Fisheries and Oceans
Canada

ADDENDUM NO. 2

Subject: Invitation to Tender No. FP802-170138
Cash Flow Rock - Pier and Tower Replacement

Chart 2205

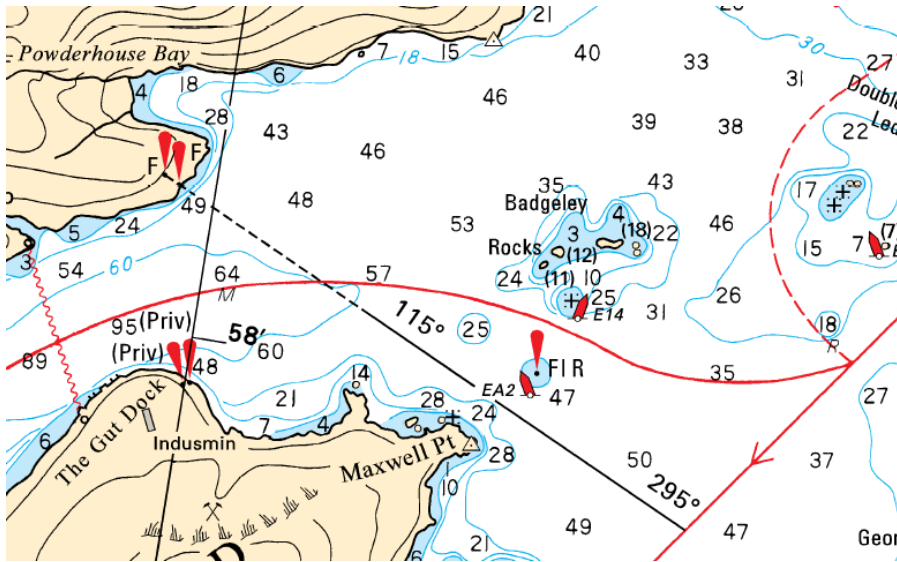
Question 6: The Note on the Drawing says "Water Depth Outside "Rock Shelf" Area Quickly Drops Off". Please forward sounding information outside the rock shelf (100 foot radius) which will show the depths of water on site for the barge and tug to operate. Also, this will give an idea of the size of spud legs the barge must have to spud down in this location.

Answer: There is no available sounding information. Contractors are responsible to evaluate all difficulties associated with completing the contract as per the contract conditions. Shown below are clips of the most recent nautical charts showing the project location.

Depths are in feet and are reduced to chart datum. Elevations are in feet above chart datum. Image is not to scale.
